## **PLN15/1176.02 – 2 Gough Street, Cremorne – Application referrals**

**Attachment 1 - PLN15/1176.02 - 2 Gough Street, Cremorne - Referrals (consolidated)**

**INDEPENDENT URBAN DESIGN ADVICE**

Proposed Stage 2 Development at 2 Gough Street Cremorne

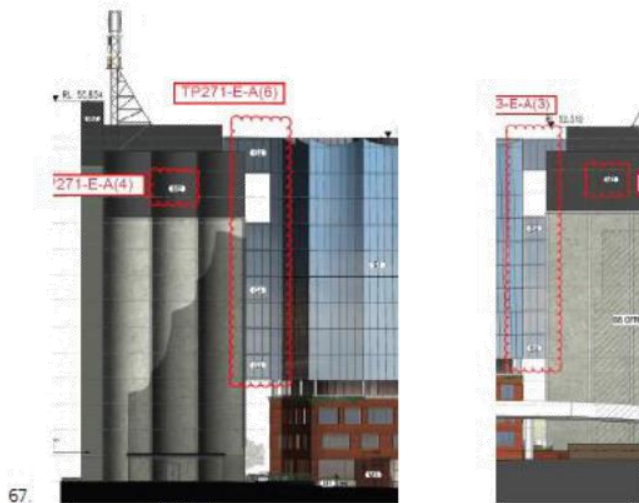
- 50. A similar poor result arises in the courtyard, an area of primary outlook for upper level offices and for ground level dining areas.

- 51.
  - a) Presently the northern interface for the courtyard is dominated by substation double doors with only a small area provided as an end of travel access and storage area and a fire exit the balcony activated on the image is shown as a roof on plans and the restaurant entry depicted on the image is shown as a solid wall on plans These interfaces are in part demanded by the decision to establish an elevated colonnade accessible only via stairs from Harcourt Parade to the south.

- b) Desirably these back of house services would be pushed to this southern interface to ensure the northern outcomes deliver high quality shared spaces rather than a de-facto service zone outcome and character as currently proposed.
